CITY OF OREGON CITY

PLANNING COMMISSION

AGENDA

WR 02-18 (*Quasi-Judicial Water Resource Hearing*), Tom Skaar/Pacific Western Homes, Inc.; Request for a Water Resource determination and reduction of the vegetated corridor in accordance with Section 17.49.050.1 of the Oregon City Municipal Code for the property identified as Map 2S-2E-28AD, Tax Lot 4300.

VEGETATED CORRIDOR BASIS

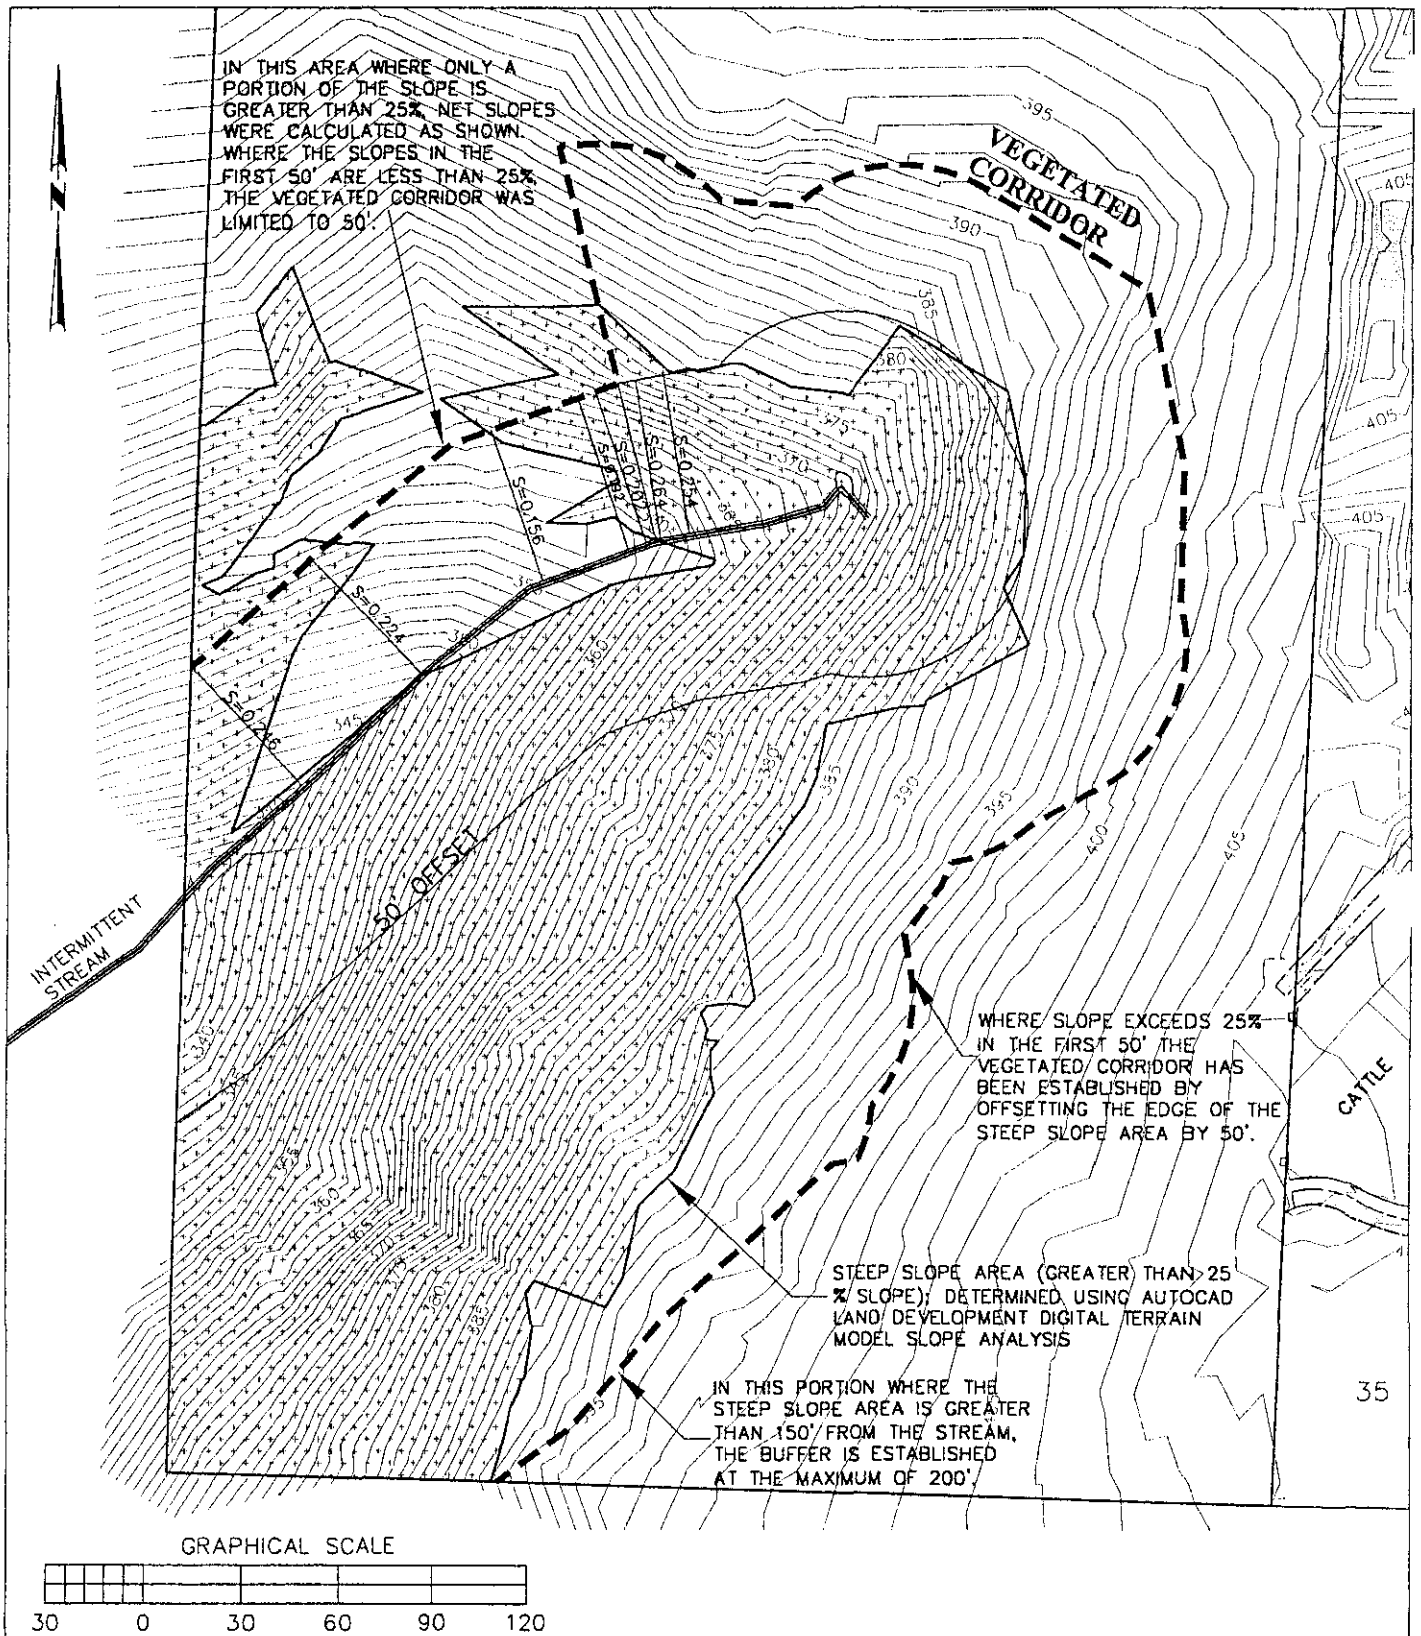
The applicant has proposed a 50-foot to 200-foot wide vegetated buffer (Exhibit 2, Figure 3 of 5) area along the intermittent stream depending on the steepness of the adjacent slopes. Staff concurs with the applicants findings concerning width of the vegetated buffer (Water Quality Resource Area).

Findings: Figure 3 of 5 of the water resource report (Exhibit 2) indicates the areas where the slopes are in excess of 25% and are 150 feet or less from the delineated water feature. Exhibit 4 depicts the proposed reduction of the vegetated corridor from 50 feet to 25 feet.

The proposed reduction is not supported by the slope analysis submitted by Environmental Technology Consultants, Figure 3 of 5 for proposed Lot 2 (Exhibit 2). It appears that the 25% slope exceeds 150 feet from the water feature for approximately 45 feet in a south to north direction along the west (rear) lot line of proposed lot number 2, thus the vegetative corridor reduction would not be applicable for this section as the slope is in excess of 150 feet from the water feature. The applicant can meet this criterion by complying with Condition of Approval 11, which requires the applicant to reconcile the slope analysis with the proposed vegetated corridor width reduction.

Konkol said the applicant has also requested a vegetated width reduction and he (Konkol) used an overhead to better show Exhibit 2, no. 3 of 5, which is the applicant's submittal to show the vegetated corridor.

VEGETATION ASSOCIATIONS

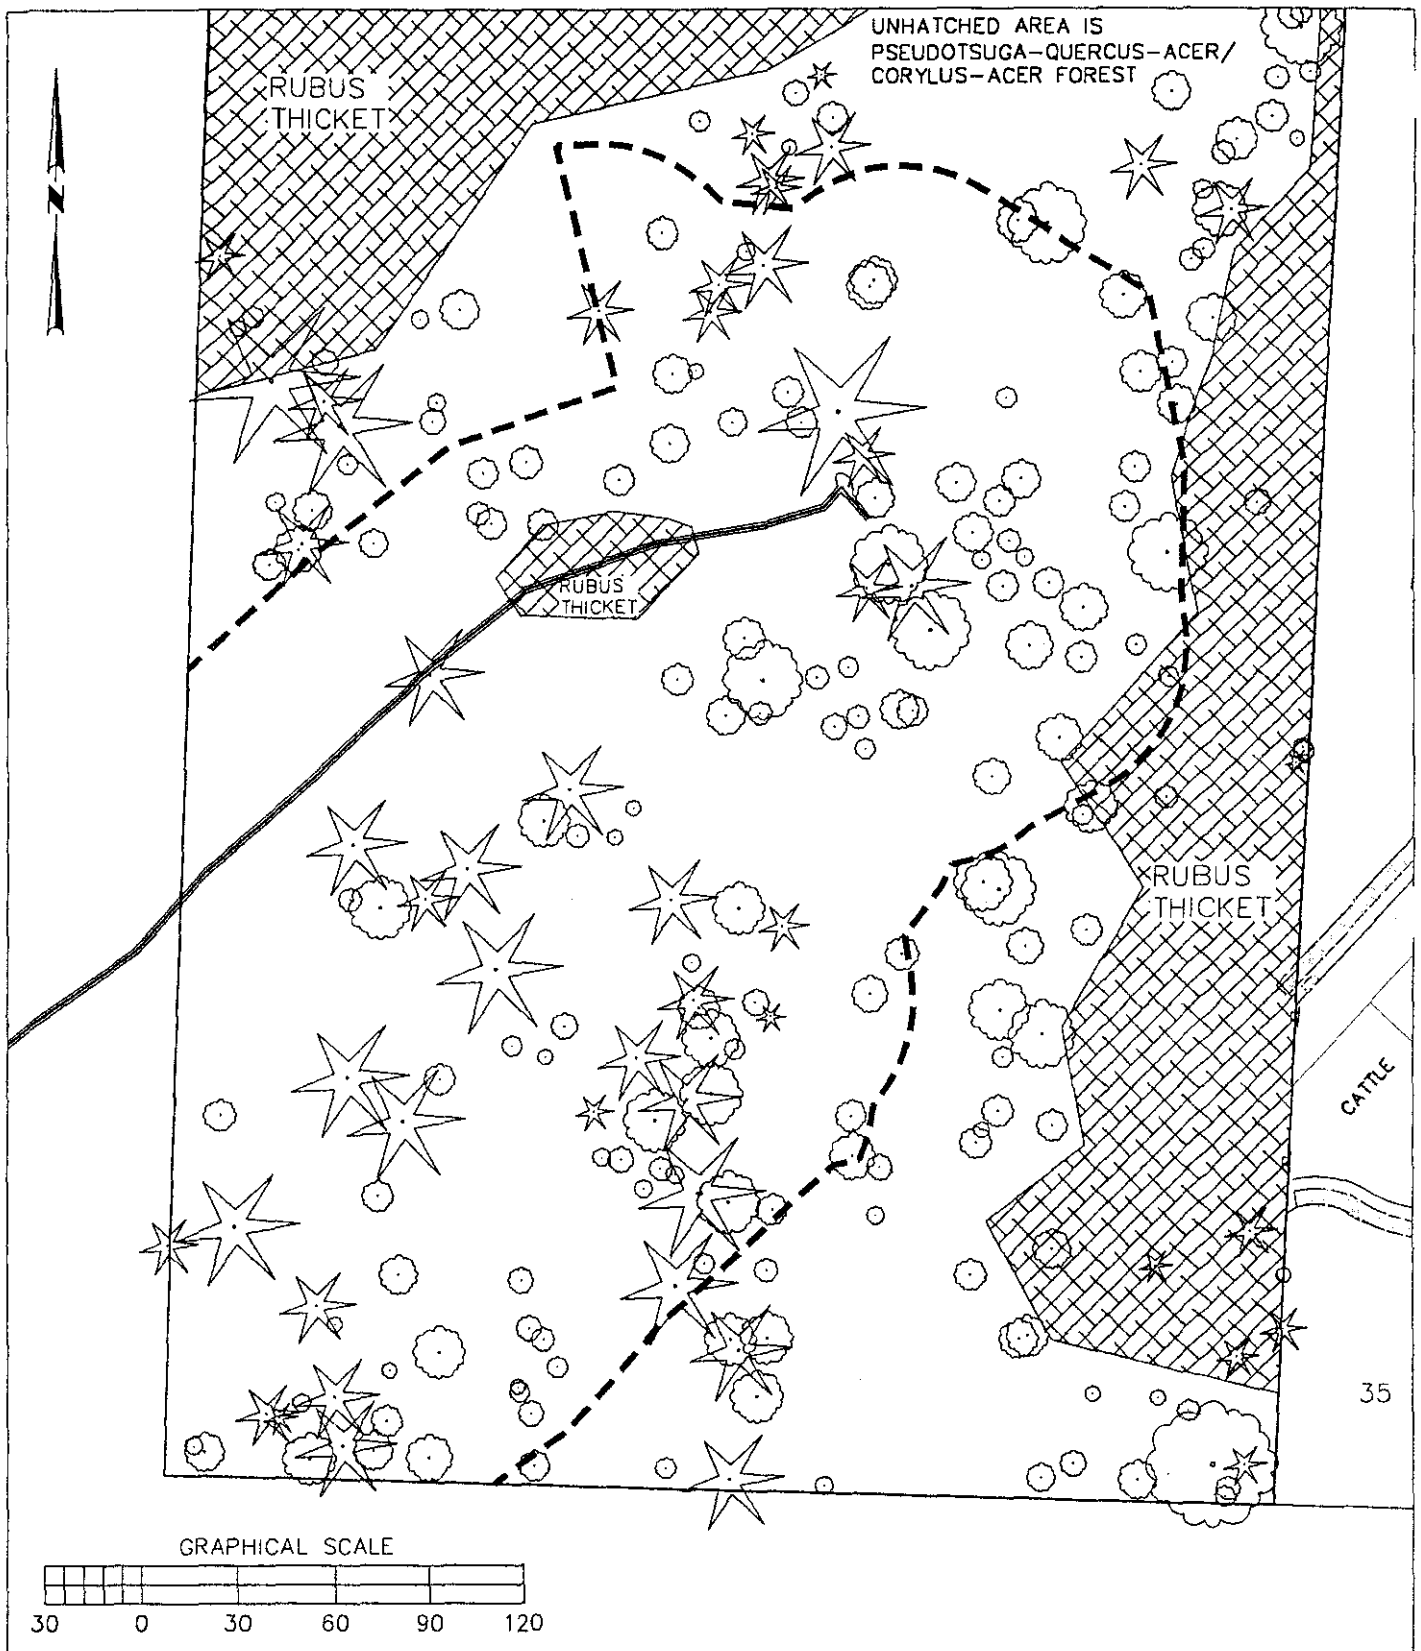
Findings: The location of nuisance plants are shown on Figure 5 of 5 included in the water resource report from Environmental Technology Consultants (Exhibit 2).

Mengelberg referred to Figure 5 of 5 which shows that there are maple, oak, hazelnut, and perhaps Douglas fir trees, and **Orzen** said the undergrowth is mostly native shrubs. **Konkol** concurred, saying there are a few areas of nuisance, but for the most part it is in a very natural state with native vegetation predominating.

VEGETATED CORRIDOR BASIS

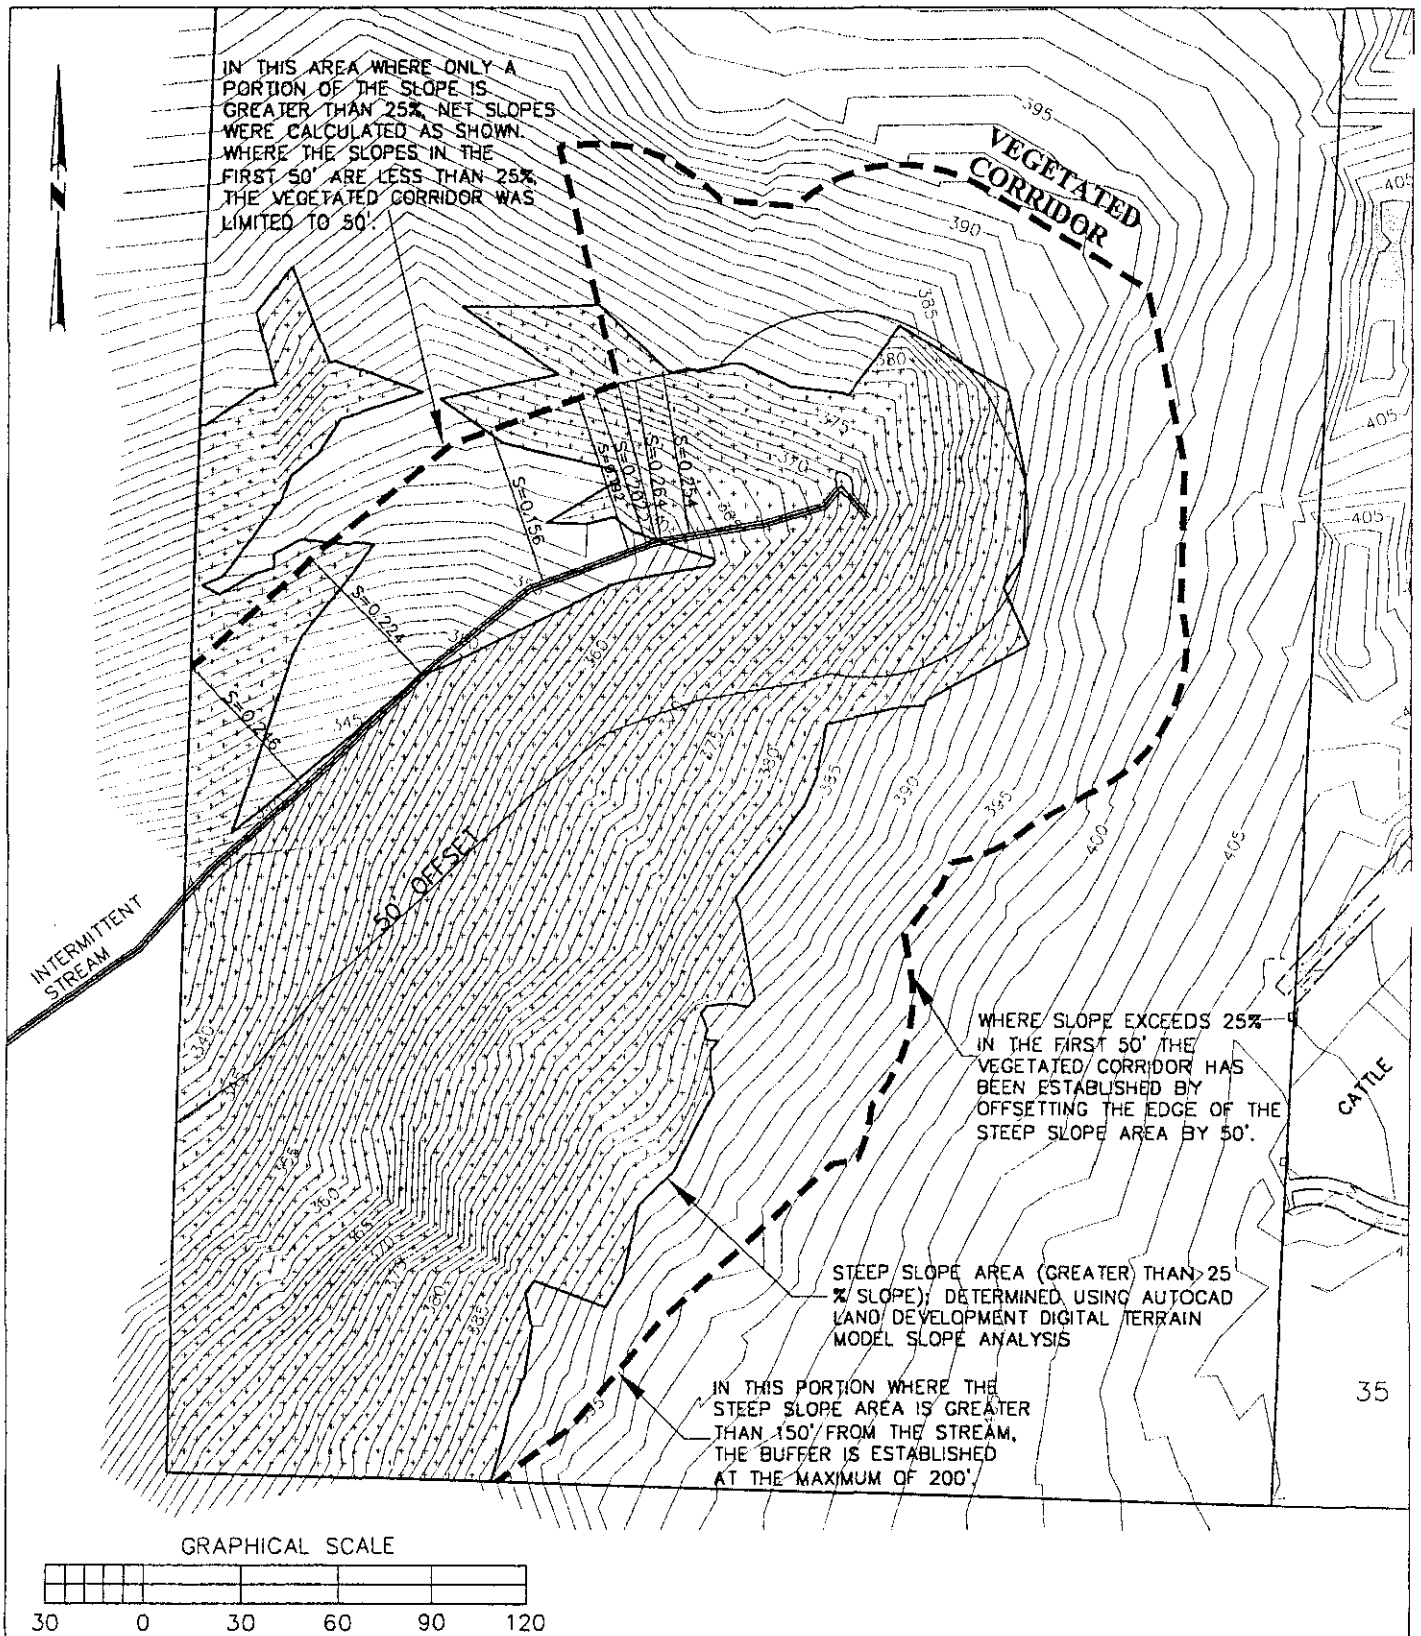
The applicant has proposed a 50-foot to 200-foot wide vegetated buffer (Exhibit 2, Figure 3 of 5) area along the intermittent stream depending on the steepness of the adjacent slopes. Staff concurs with the applicants findings concerning width of the vegetated buffer (Water Quality Resource Area).

Findings: Figure 3 of 5 of the water resource report (Exhibit 2) indicates the areas where the slopes are in excess of 25% and are 150 feet or less from the delineated water feature. Exhibit 4 depicts the proposed reduction of the vegetated corridor from 50 feet to 25 feet.

The proposed reduction is not supported by the slope analysis submitted by Environmental Technology Consultants, Figure 3 of 5 for proposed Lot 2 (Exhibit 2). It appears that the 25% slope exceeds 150 feet from the water feature for approximately 45 feet in a south to north direction along the west (rear) lot line of proposed lot number 2, thus the vegetative corridor reduction would not be applicable for this section as the slope is in excess of 150 feet from the water feature. The applicant can meet this criterion by complying with Condition of Approval 11, which requires the applicant to reconcile the slope analysis with the proposed vegetated corridor width reduction.

Konkol said the applicant has also requested a vegetated width reduction and he (Konkol) used an overhead to better show Exhibit 2, no. 3 of 5, which is the applicant's submittal to show the vegetated corridor.

VEGETATION ASSOCIATIONS

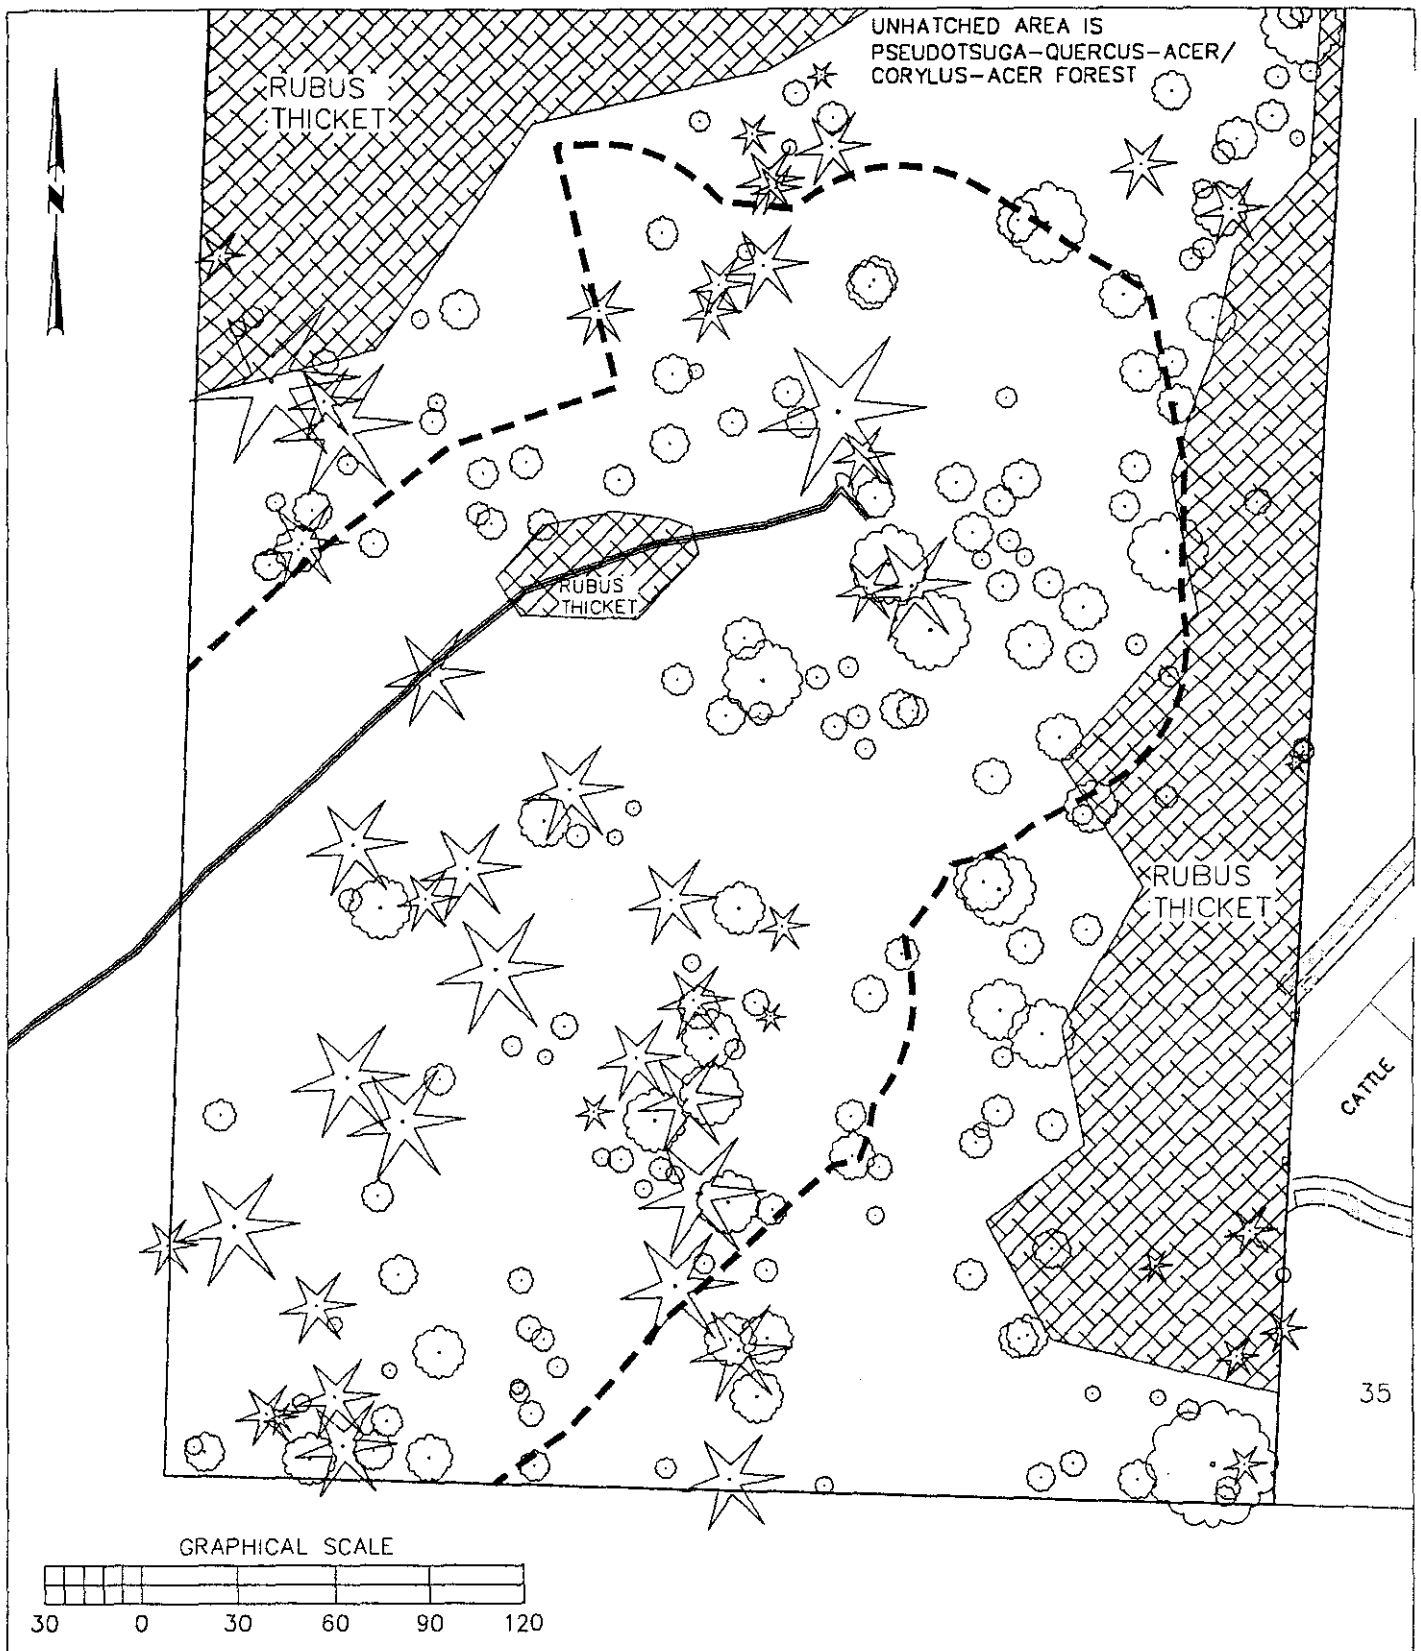
Findings: The location of nuisance plants are shown on Figure 5 of 5 included in the water resource report from Environmental Technology Consultants (Exhibit 2).

Mengelberg referred to Figure 5 of 5 which shows that there are maple, oak, hazelnut, and perhaps Douglas fir trees, and **Orzen** said the undergrowth is mostly native shrubs. **Konkol** concurred, saying there are a few areas of nuisance, but for the most part it is in a very natural state with native vegetation predominating.
